V2500-A5 SERIES PROPULSION SYSTEM SERVICE BULLETIN

This document transmits Revision 1 to Service Bulletin EV2500-70-0888 and Revision 1 to the Supplement

V2500-ENG-70-0888

ENGINE – FUEL AND CONTROL – ELECTRONIC ENGINE CONTROL (EEC) – NEW SLIMLINE CASTING

LOCATION OF THE ELECTRONIC ENGINE CONTROL (EEC)
Figure 1

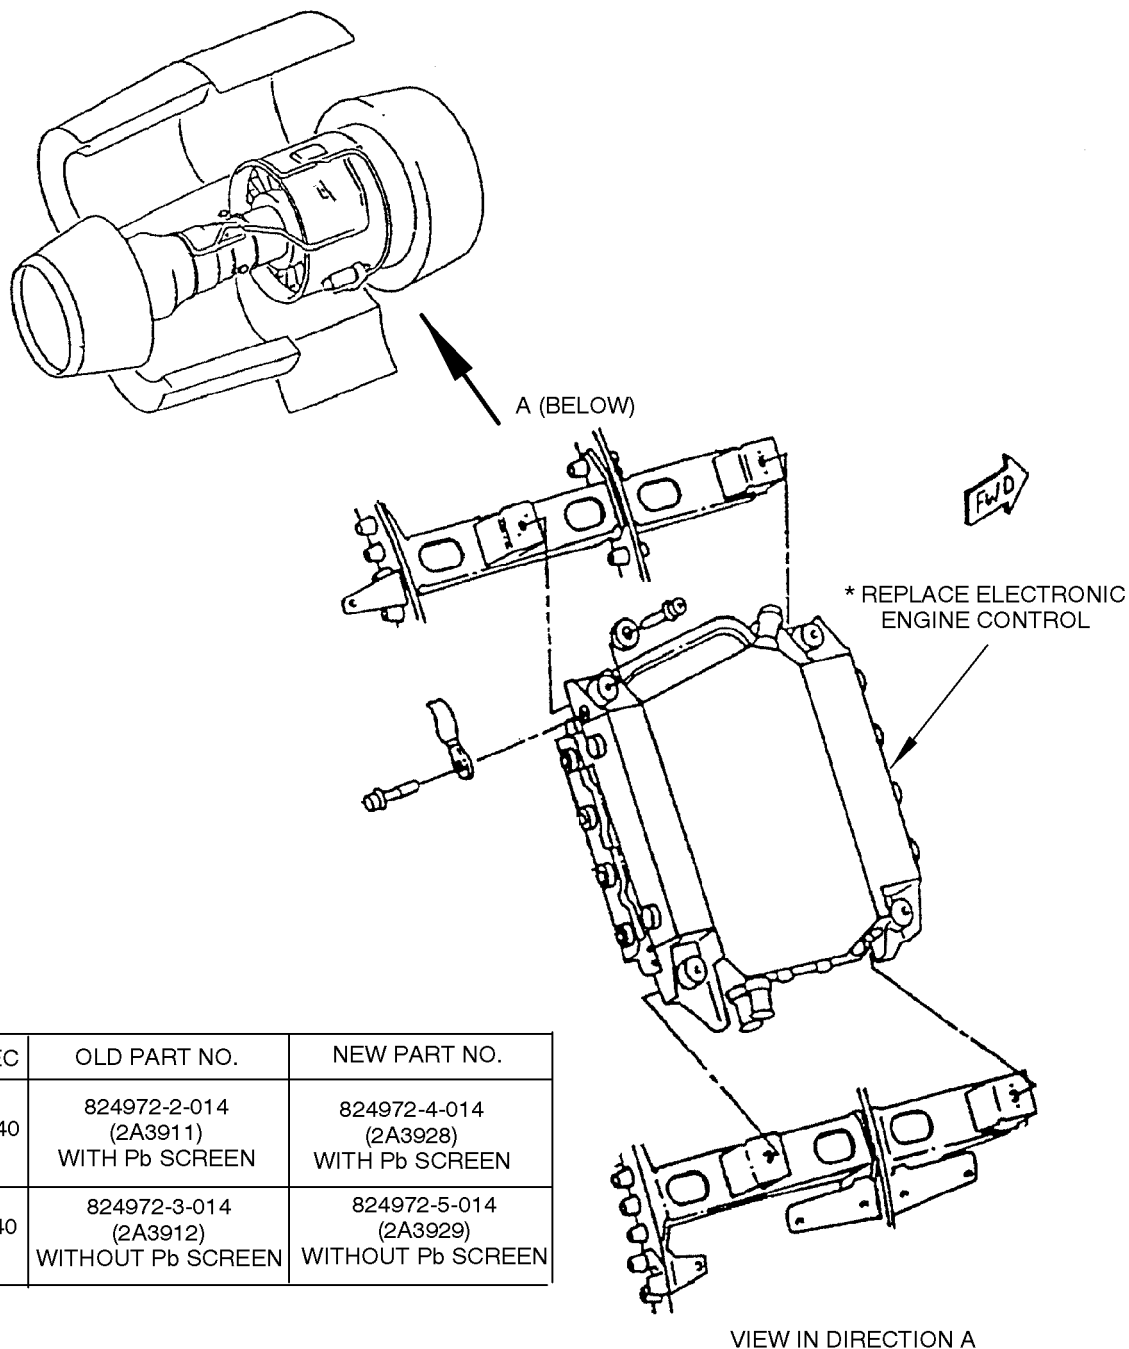
- (1) Replace the EEC with one that has the slimline casting.
- (2) Recording Instructions
 - (a) A record of accomplishment is not required.

* EEC	OLD PART NO.	NEW PART NO.
150-40	824972-2-014 (2A3911) WITH Pb SCREEN	824972-4-014 (2A3928) WITH Pb SCREEN
150-40	824972-3-014 (2A3912) WITHOUT Pb SCREEN	824972-5-014 (2A3929) WITHOUT Pb SCREEN

FAMILY TREE – ELECTRONIC ENGINE CONTROL REF. CATALOG SEQUENCE NO. 73-22-34-FIGURE 01-ITEM 280.

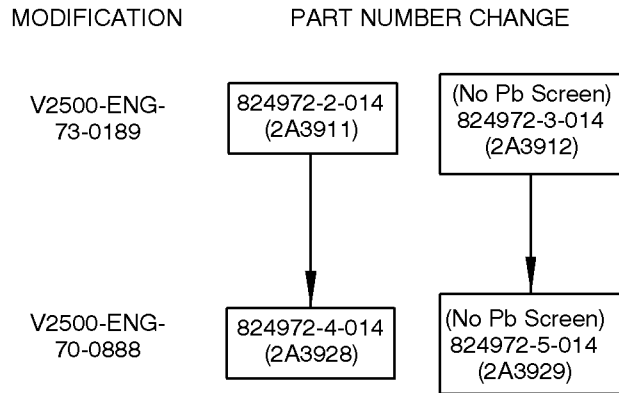
APPENDIX 1Parts Progression To Show the Changed Part in Relation to Other Parts
